Re: Edgemont at Bethesda II
Site Plan No. 820180170

Re: **SITE DEVELOPMENT STORMWATER
MANAGEMENT PLAN Revision** Request for
The Edgemont
Preliminary Plan #: 11984058A
SM File #: 283225
Tract Size/Zone: 1.38 Ac./CR-2.5
Total Concept Area: 0.85 Ac.
Lots/Block: Part of 4&5 /12
Watershed: Little Falls Branch

DATE: 16-Jan-18
TO: Jason Evans
VIKA, Inc
FROM: Marie LaBaw
RE: Edgemont at Bethesda II
820180170 11984058A 320180030

Re: **The Edgemont at Bethesda II**
Site Plan 820180170
Performance Based Code Design Justification
VIKA Project VM1148D

Fire Department Access Review

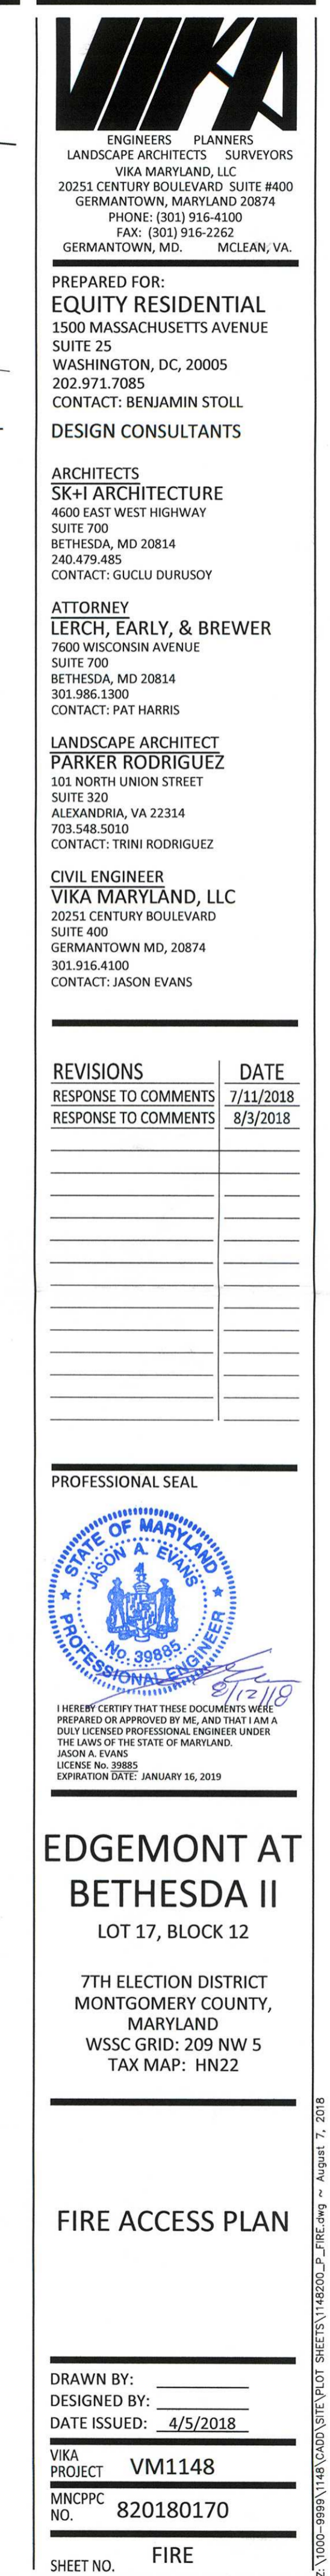
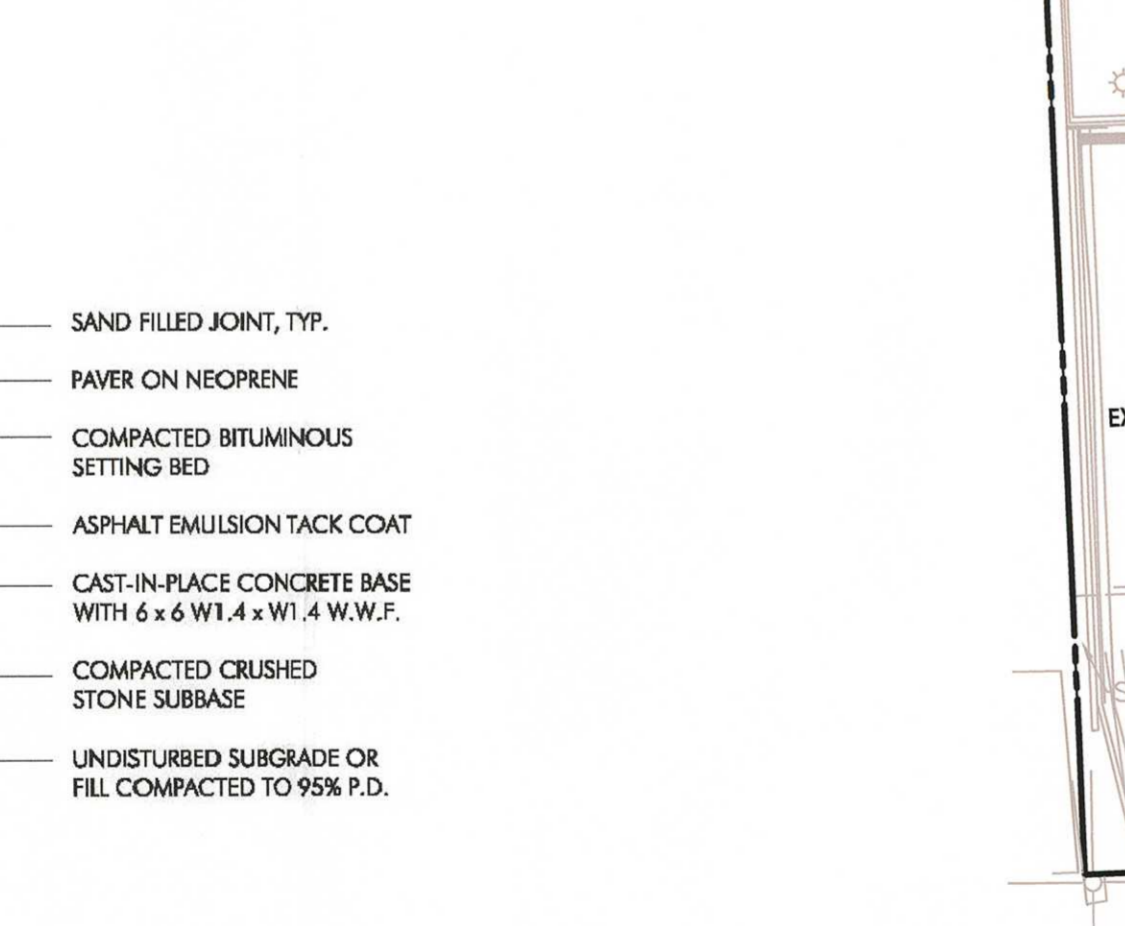
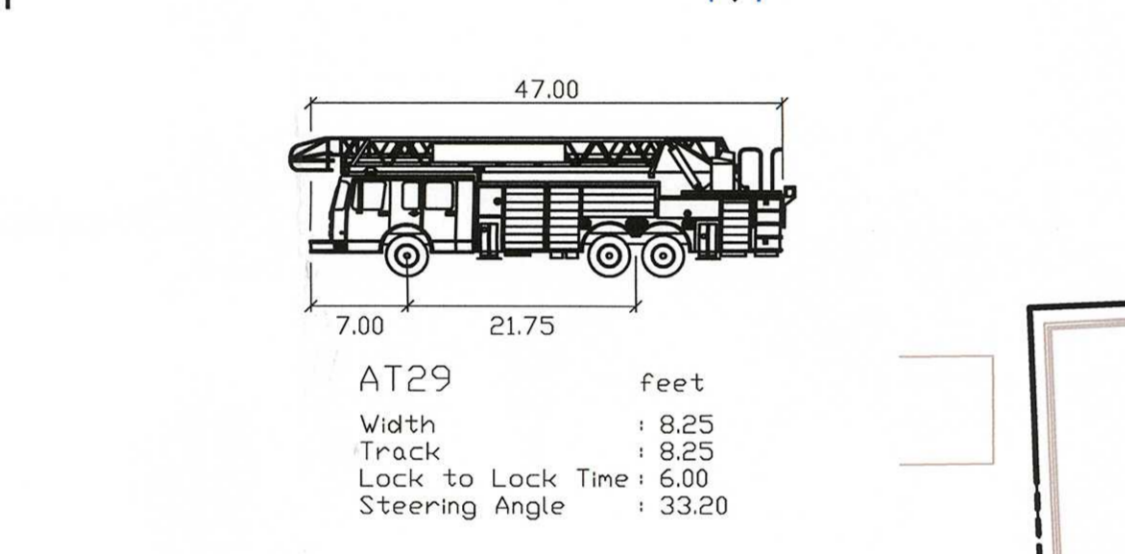
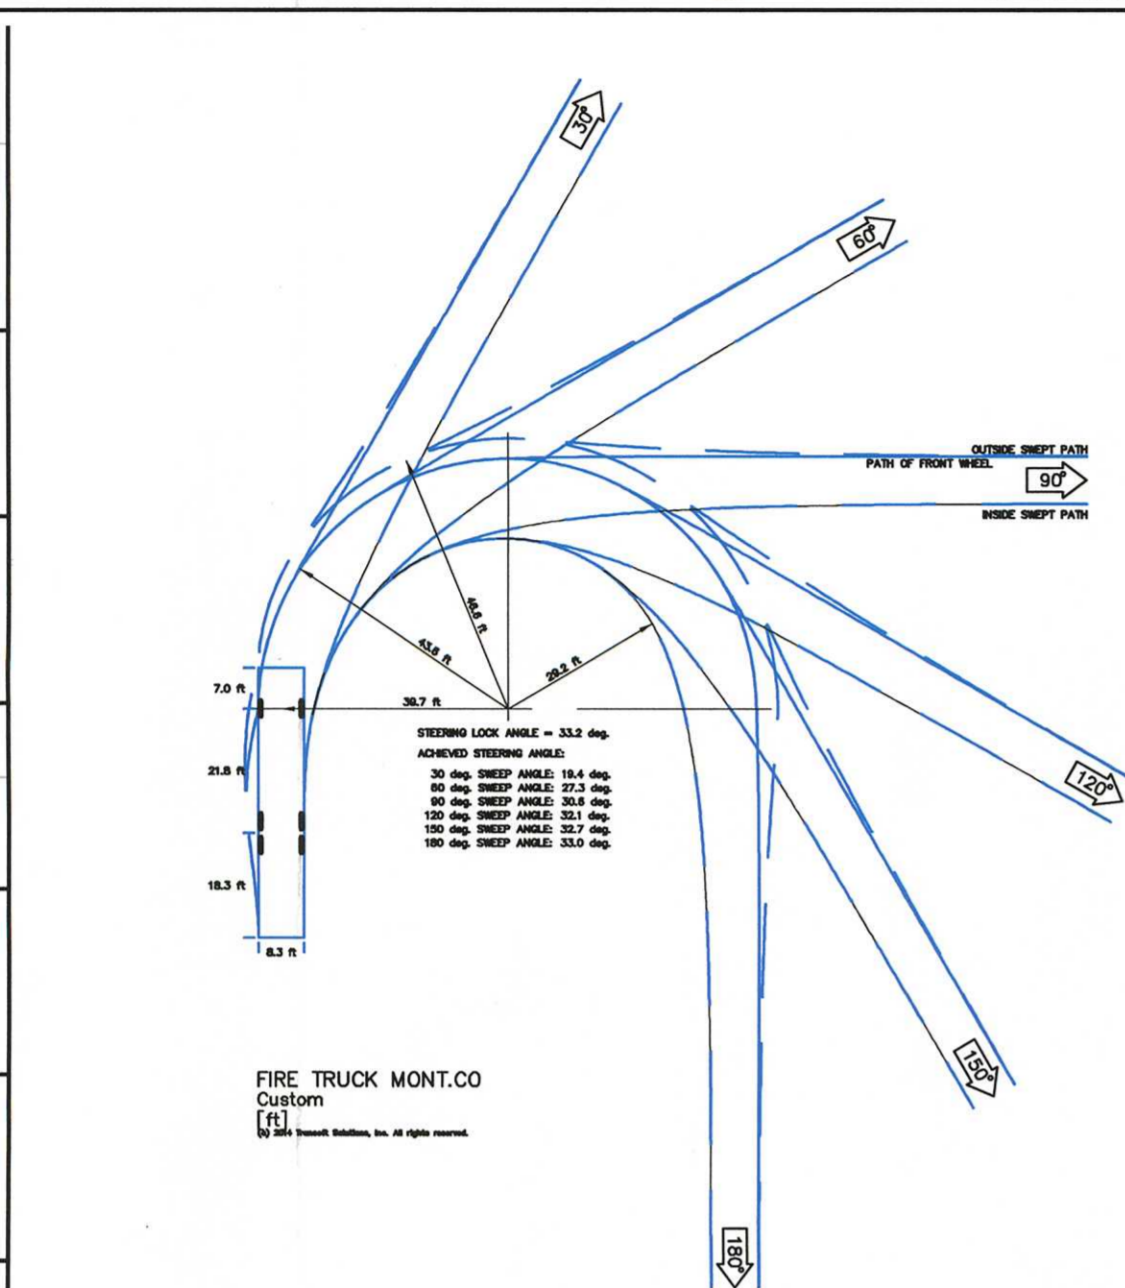
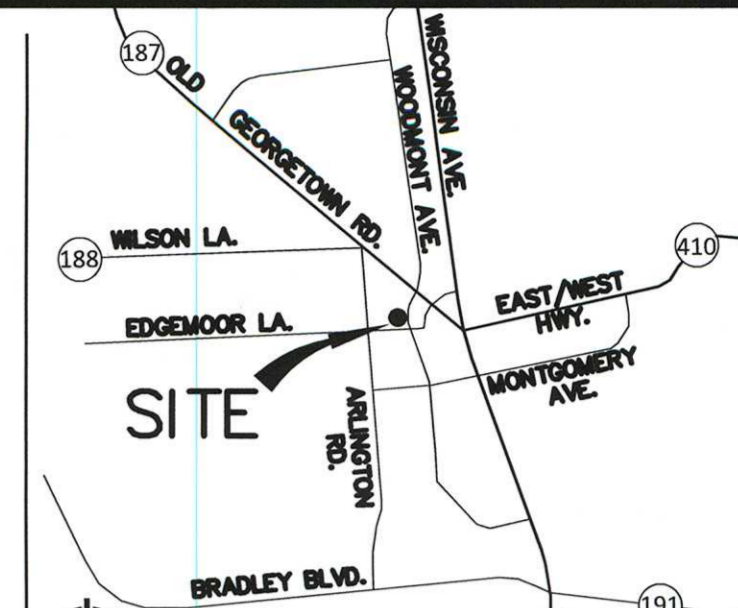
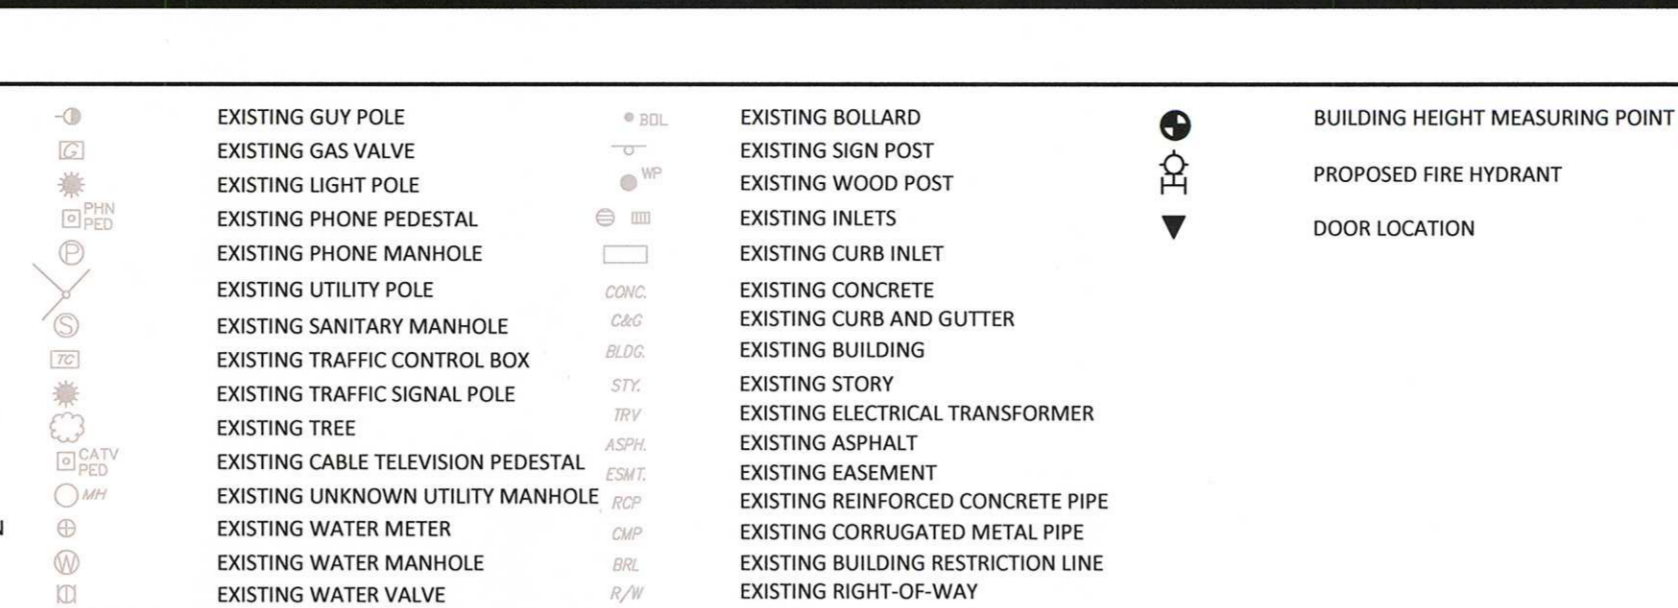
Review based only upon information contained on this plan. Does not cover unsatisfactory layout resulting from omissions, errors or failure to clearly indicate conditions on this plan. Correction of such unsatisfactory layout to afford required access will be required if found upon inspection after installation

The proposed development includes an existing multi-family building (to be retained) and a new multi-family building. The FAA for the new building is on Edgemoor Lane and Woodmont Avenue and meets prescriptive code requirements for distances from FAA, hose drag, FDC distance from fire hydrant, etc. The FAA for the existing building is via Edgemoor Lane. Although the existing vehicular drop-off area is 20' wide, it does not have current prescribed turning room for large emergency equipment thus access is limited to smaller emergency vehicles. It should be noted that the existing building does not meet current emergency access requirements for distance from the paved surface to the main side-hinge door (currently +/- 90') and is an existing non-conforming condition.

The site plan proposal includes the removal of the existing vehicular drop-off area and the installation of a new public use open space urban park. During the urban park design process, the guidance from your office was that the new design cannot exacerbate an existing non-conforming condition. In response to this guidance, we have designed a dimensionally compliant FAA for the existing building that maintains the existing distance from the FAA to the main side hinged door (+/- 90') as is provided today. While the entire urban park will be covered in a unified paving pattern throughout, apart from planting areas, the vehicular rated paver section (paver, concrete base, and subbase) in the area designated on the plan will support 85,000 lbs. This FAA pull-off from Edgemoor Lane complies dimensionally with a modified apron design measuring 35' wide at Edgemoor lane, 20' wide after 30' taper over 7.5' in combination and accessed via a proposed 6" mountable curb (MCDOT Standard MC-101.01 Combination Concrete Curb and Gutter Type 'C'). This FAA will be signed on Edgemoor Lane with 'Authorized Vehicle Signs' on either side of the vehicular rated paving area. Signs and locations to be reviewed at time of final right-of-way improvement plans. The limits of the FAA can easily be determined visually by knowing that the limits of the FAA pull-off are defined by planting beds on the left and right, and a planting bed and monument sign at the north-end of the FAA.

PLAN APPROVED

***** 8/13/2018 Site Plan 820180170 Approval - See Statement of Performance Based Design *****
